- .1 Cover Page – Addendum No.6 – 1 page;
 - .2 Civil Addendum C2 dated March 28, 2018 – 1 page;
 - .3 Architectural Addendum A4 dated March 28, 2018 – 20 pages including 9 drawings;

Architectural Addendum A4

PROJECT TITLE	East Hants Aquatic Centre
---------------	---------------------------

PROJECT NUMBER

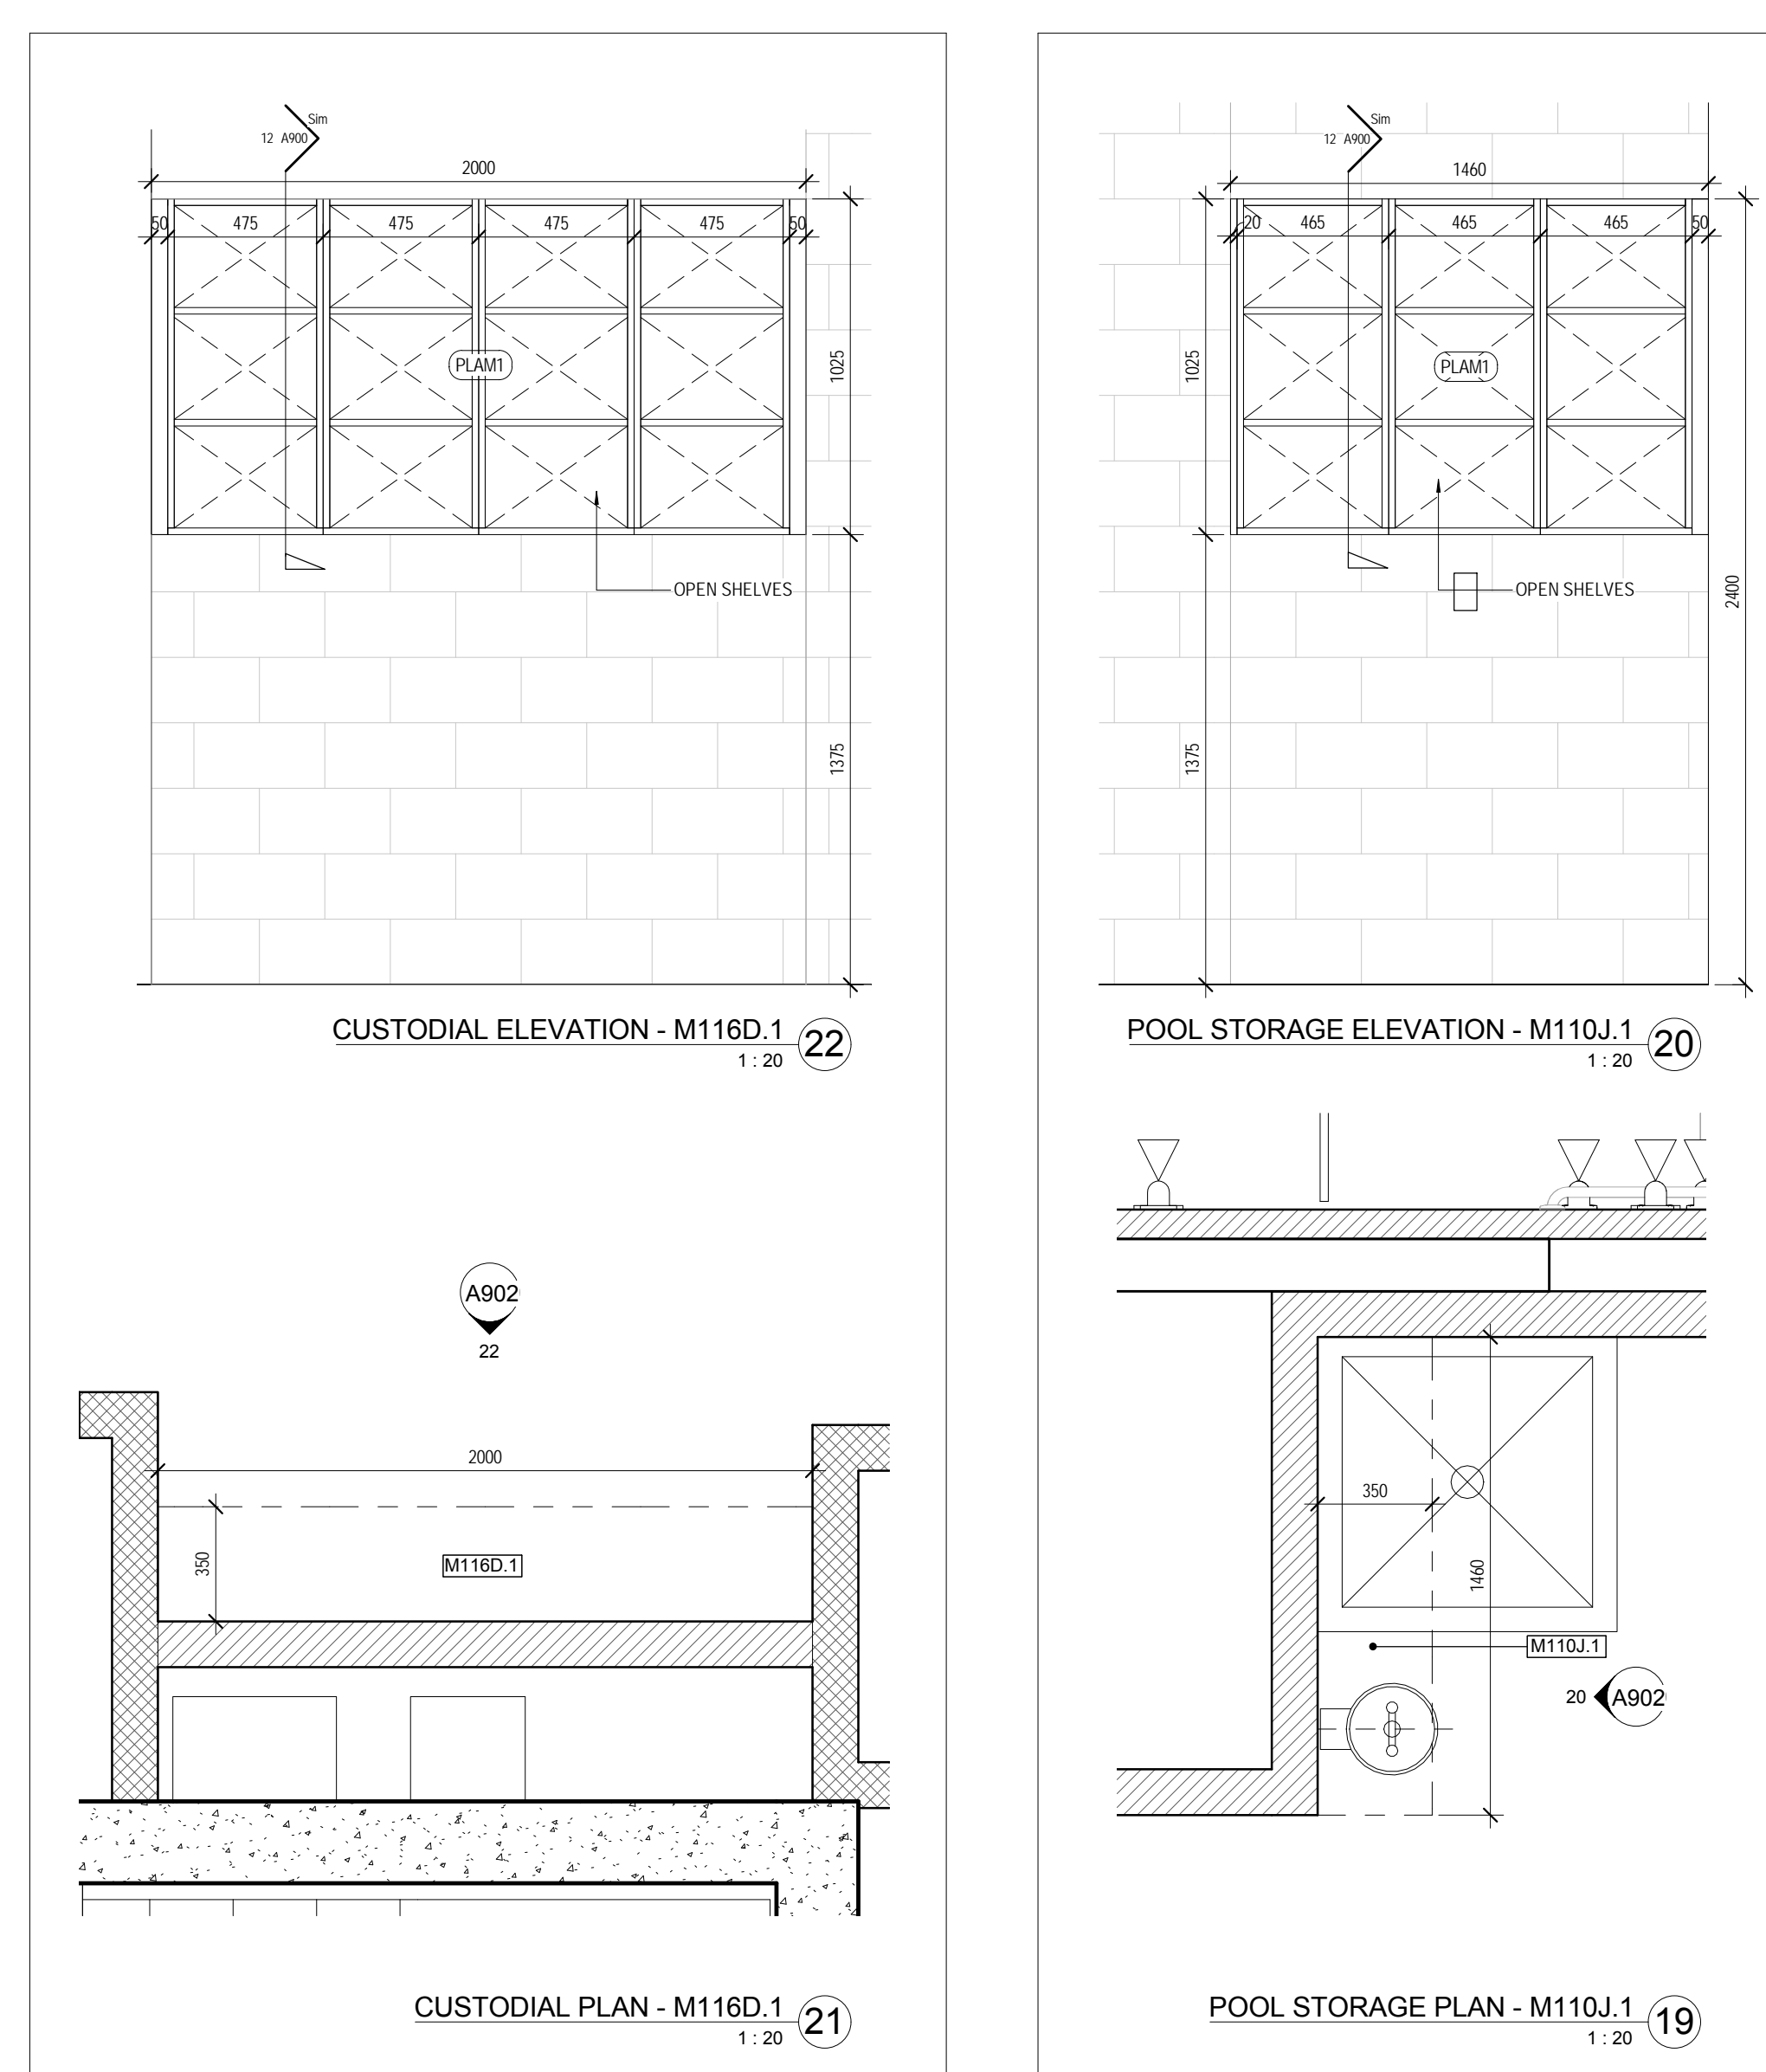
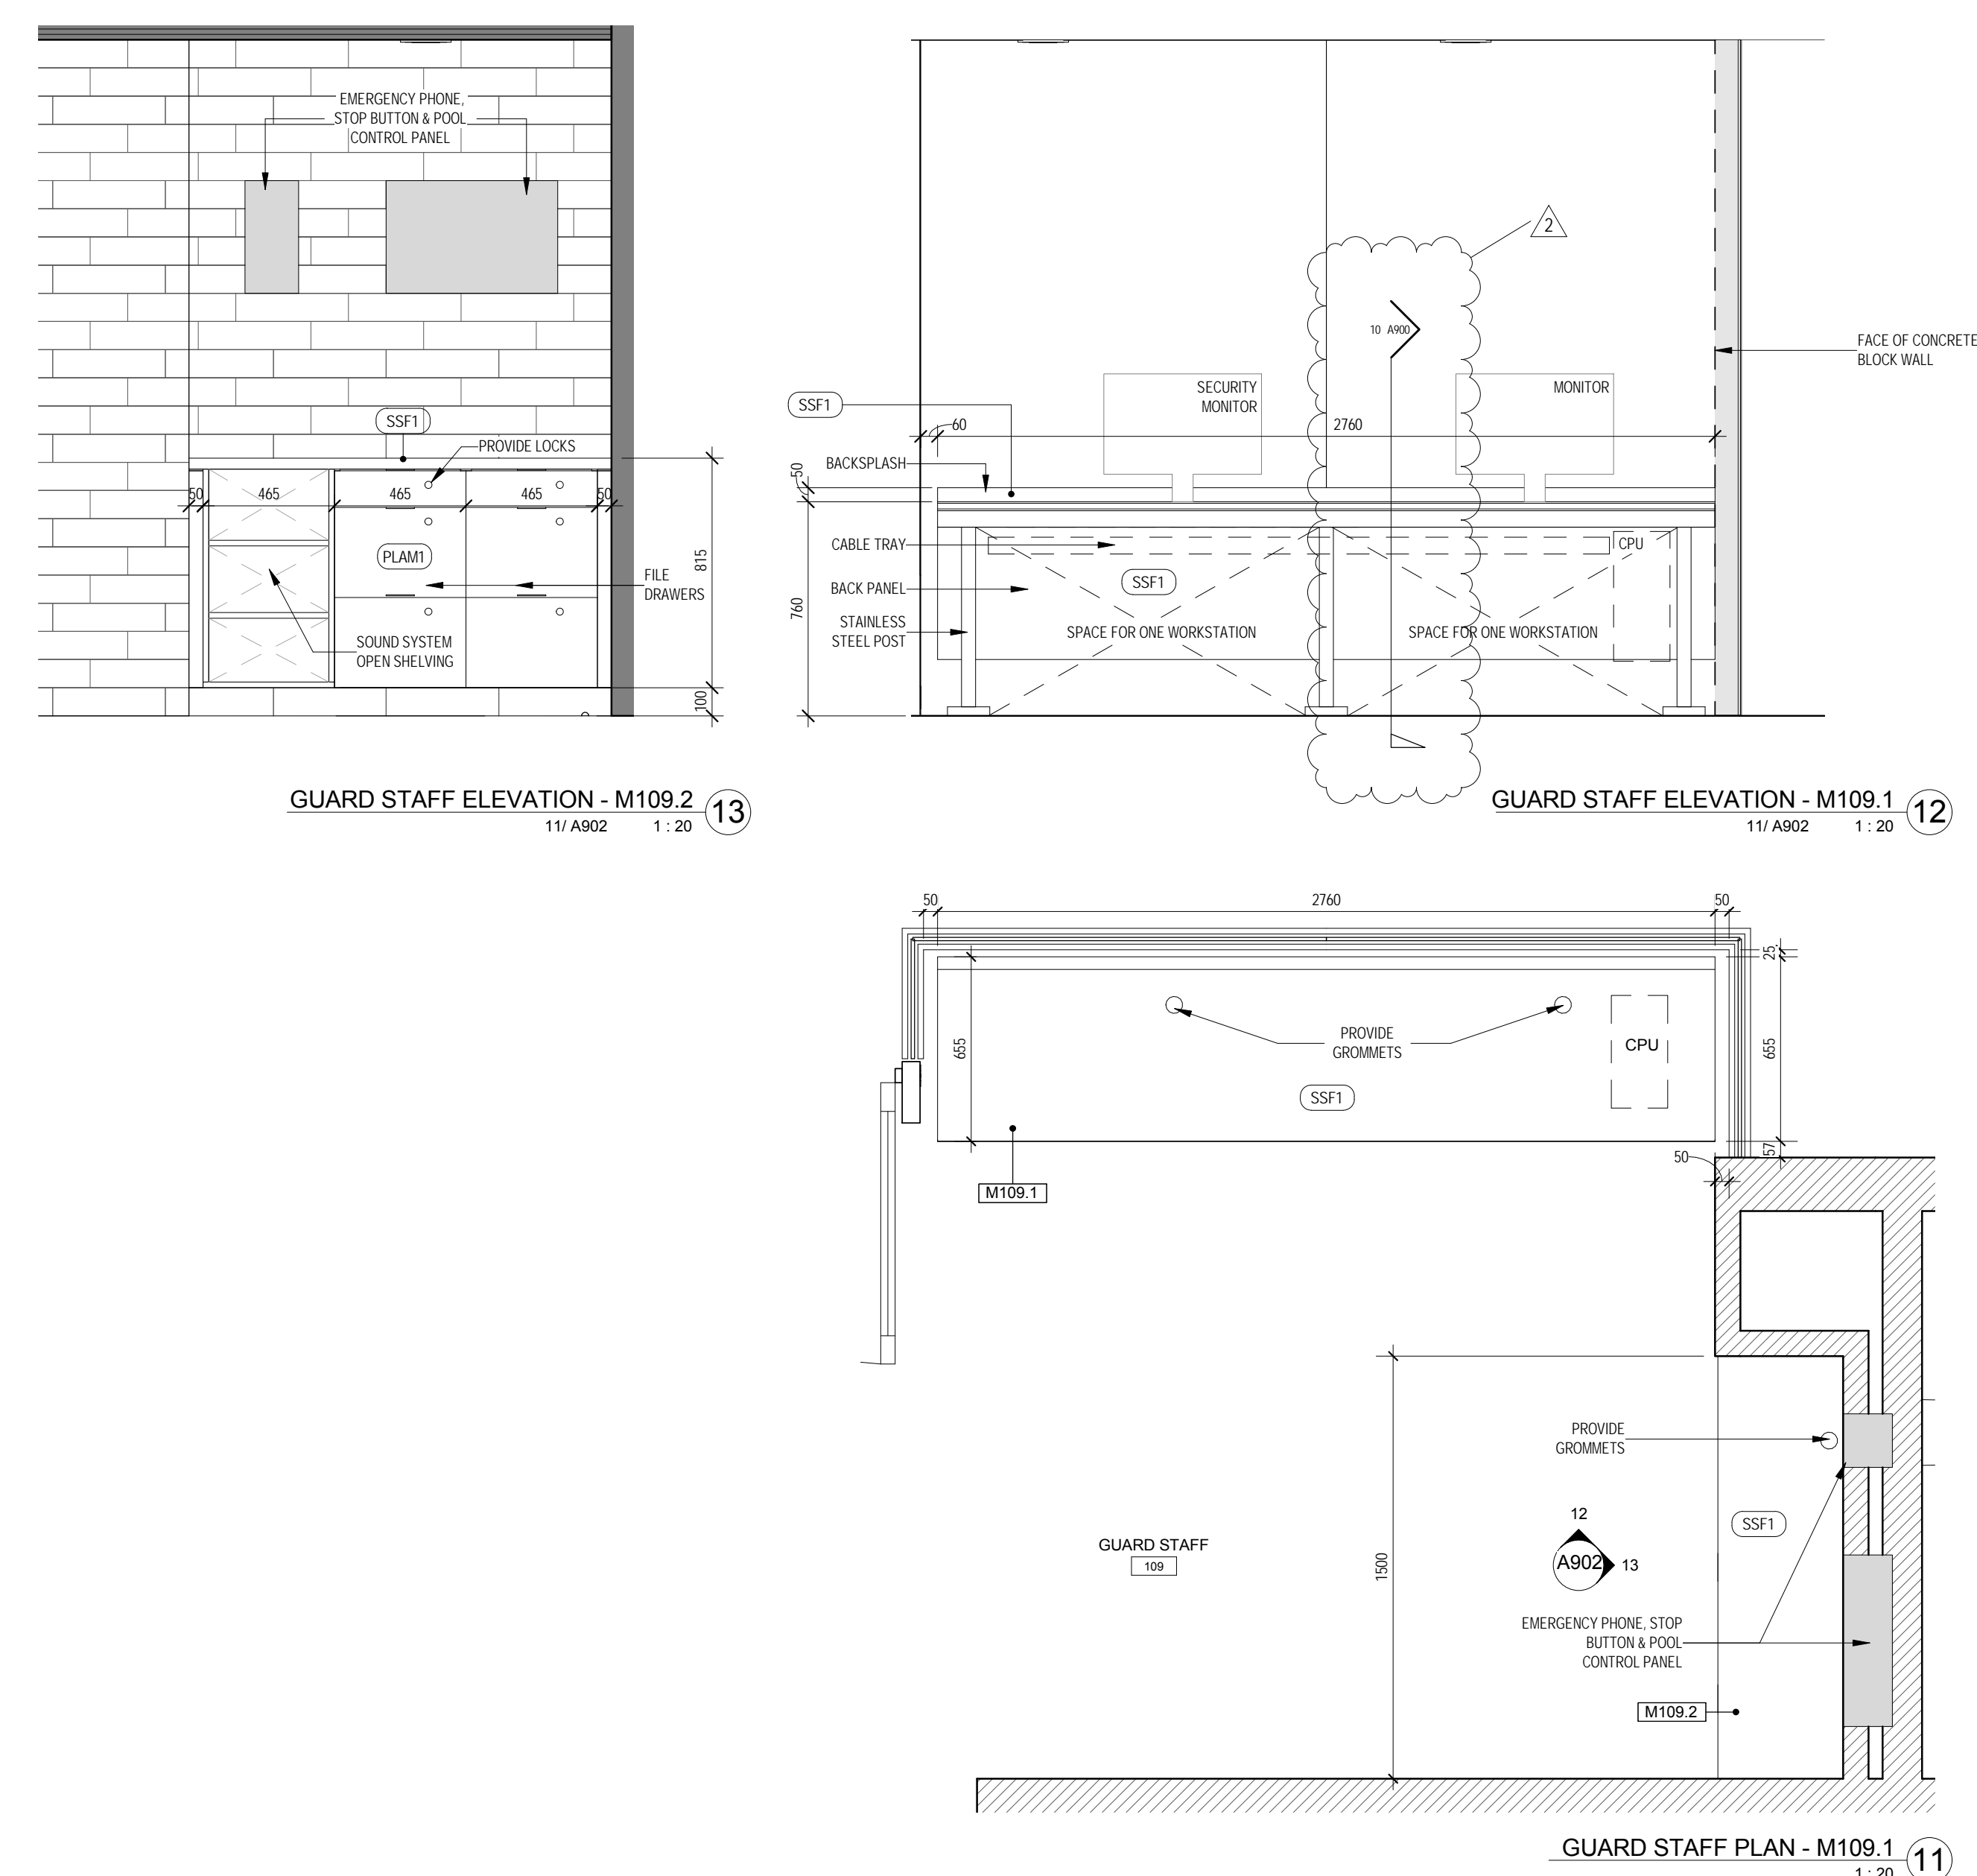
- .1 Drawing A900 “MILLWORK DRAWINGS”, dated 2018-03-28 “Issued for Addendum No.6 to replace and supersede drawing A900 “MILLWORK DRAWINGS”, dated 2018-03-01 “Issued for Tender”. Changes include but are not limited to:
 - .1 Detail 11/A900: REVISED to provide additional information regarding composition of cabinet door.

- .1 Drawing A901 “MILLWORK DRAWINGS”, dated 2018-03-28 “Issued for Addendum No.6 to replace and supersede drawing A901 “MILLWORK DRAWINGS”, dated 2018-03-01 “Issued for Tender”. Changes include but are not limited to:
 - .1 Detail 12/A901: REVISED to accommodate communications box, phone BIX and TV panels.
 - .2 Detail 13/A901: REVISED to accommodate communications box, phone BIX and TV panels.
